Access Compliance Report Public Rights-of-Way (Pedestrian Signals)

Main Street: **MAGNOLIA_AVE** Cross Street: **KATELLA_AVE** Location: **NE**

ADA ID: **SGRK210921122251** Signal Type: **One Push Button-APS** Overall Compliance: **No** Severity Scores: **BTN 1: 25** **BTN 2: N/A** **No BTN: N/A**

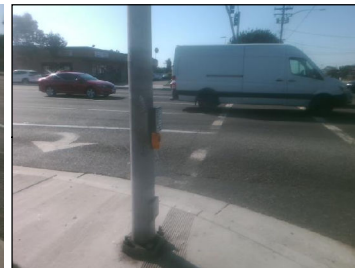
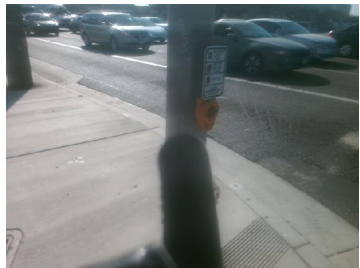
OC Std/PROW: **R404.2**

Possible Solutions: Remove and Replace Clear Space.
